8. Principles of bridge operation

Change the text immediately following this heading (8) as indicated:

20 **Figure 8-16—Effect of authorization Controlled and Uncontrolled Port connectivity**

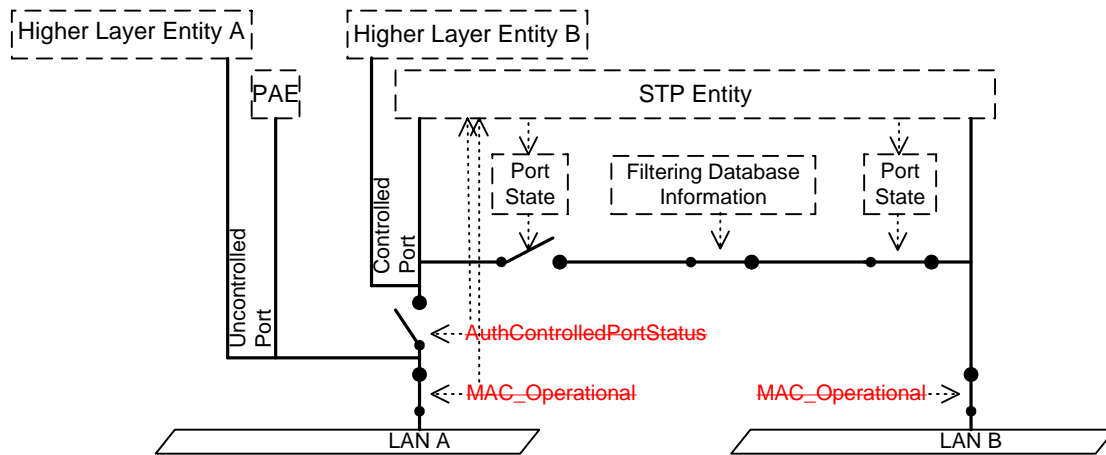
Figure 8-16 illustrates the connectivity provided to Higher Layer Entities if the MAC entity is physically capable of transmitting and receiving frames, ~~i.e., MAC_Operational is TRUE~~, but [MAC Operational is FALSE for the Controlled Port](#) ~~AuthControlledPortStatus is Unauthorized~~. Higher Layer Entity A and the PAE ~~(the port access entity that operates the authorization protocol)~~ are connected to ~~the an~~ Uncontrolled Port and can transmit and receive frames using the MAC entity associated with the Port for LAN A, which Higher Layer Entity B cannot. None of the three entities can transmit or receive to or from LAN B.

1 *Change Figure 8-16 as follows, also removing the arrows from the deleted text.*
 2
 3
 4
